Thompson-Nicola Regional District

Subject: **Revised** Subdivision Application No. SD-P-161 (02-015-15367)
Proposed Subdivision of **Lot 7 & 8**, Section 18, Township 23, Range 16, W6M,
KDYD, Plan KAP86170 - Vinsulla, BC (Daniel Arundel)

Planning Services has reviewed the Revised Plan of Subdivision dated January 18, 2011, where the two-lot subdivision of Lot 8 has been expanded to include Lot 7 Plan KAP86170. Our comments regarding the Regional District requirements for the revised for the subdivision are listed below.

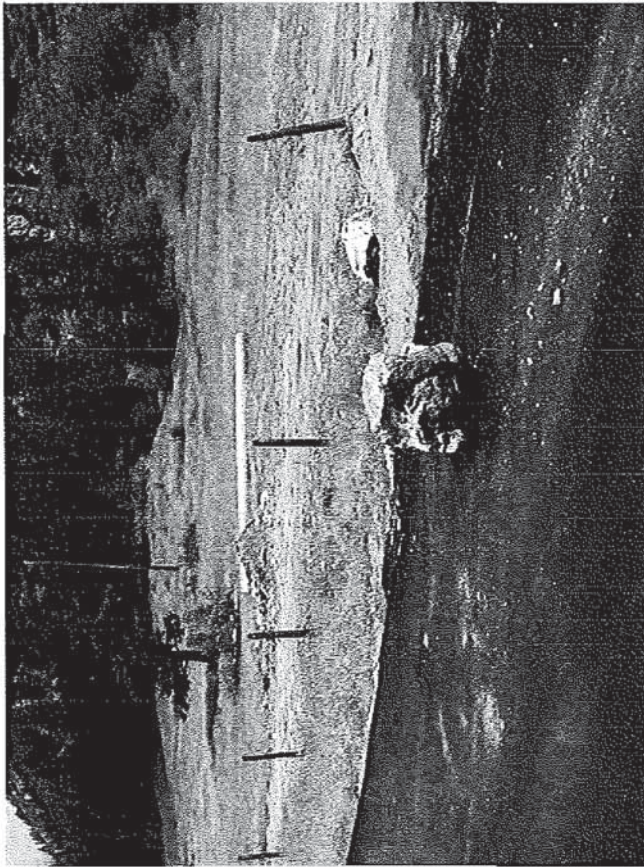
no shoulder
base material consists of fine
very little gravel base.

- Rocks blocking access need to be removed.
- paved throat to be extended to fence line

Culvert to be installed.

Fence to be re-installed.

LOT 7, SEC 18, TP 23, R 16, W6M
KAMLOOPS DIVISION YALE DISTRICT,
PLAN KAP86170

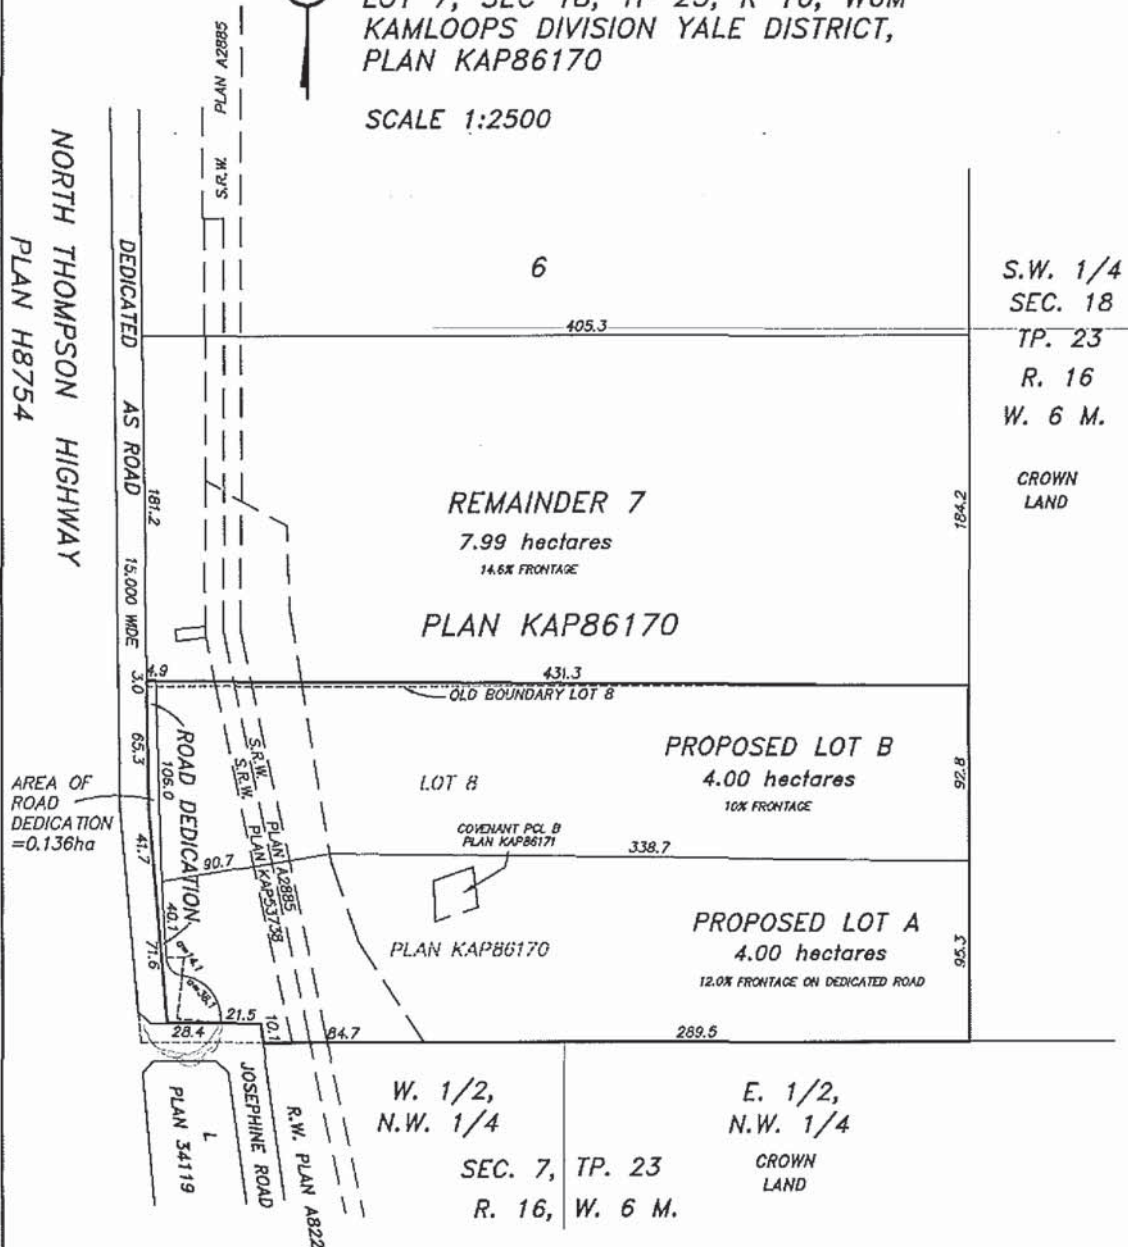
The Ministry has reviewed your proposal to adjust the property line between Proposed Lot B and Lot 7 to dedicate frontage road and still provide the minimum parcel size of 4ha for Proposed Lots A & B, as shown on the drawing prepared by All North Land Surveyors, dated January 18, 2011.

The Ministry and the TNRD (Letter dated February 7, 2011), support the revised plan. The PLA dated December 6, 2010 still applies. Once the outstanding items of the PLA dated December 6, 2010 have been completed, please submit the revised subdivision plans to the Ministry for final approval. Please note, the final fees will be \$350.00, as there are three lots being created.
